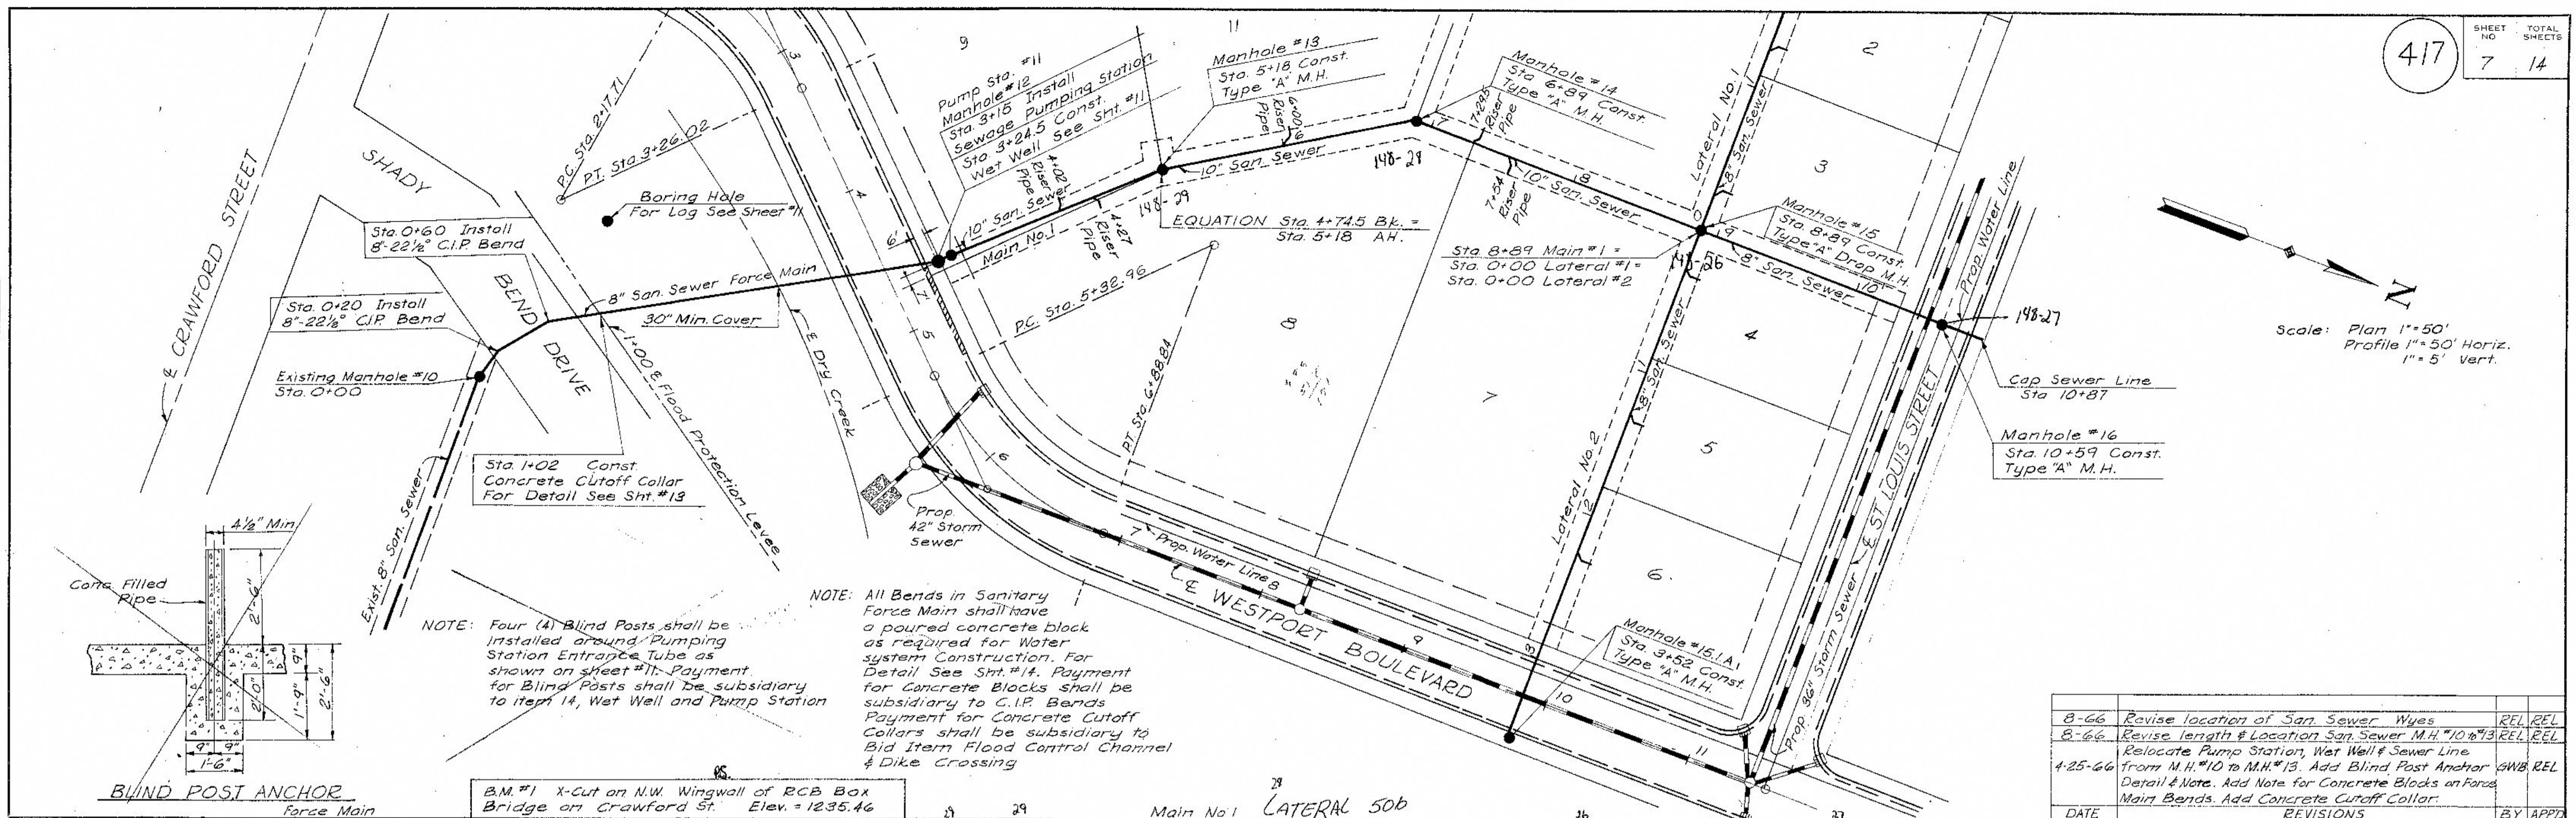
DATE	REVISIONS	BY	APP'D
8-66	Revise location of San. Sewer Wyes	REL	REL
8-66	Revise length & location San. Sewer M.H. #10 to #13	REL	REL
4-25-66	Relocate Pump Station, Wet Well & Sewer Line from M.H. #10 to M.H. #13. Add Blind Post Anchor Detail & Note. Add Note for Concrete Blocks on Force Main Bends. Add Concrete Cutoff Collar.	GWB	REL

NOTE: All Bends in Sanitary Force Main shall have a poured concrete block as required for Water system Construction. For Detail See Sht. #14. Payment for Concrete Blocks shall be subsidiary to C.I.P. Bends. Payment for Concrete Cutoff Collars shall be subsidiary to Bid Item Flood Control Channel & Dike Crossing.

NOTE: Four (4) Blind Posts shall be installed around Pumping Station Entrance Tube as shown on sheet #11. Payment for Blind Posts shall be subsidiary to item 14, Wet Well and Pump Station.
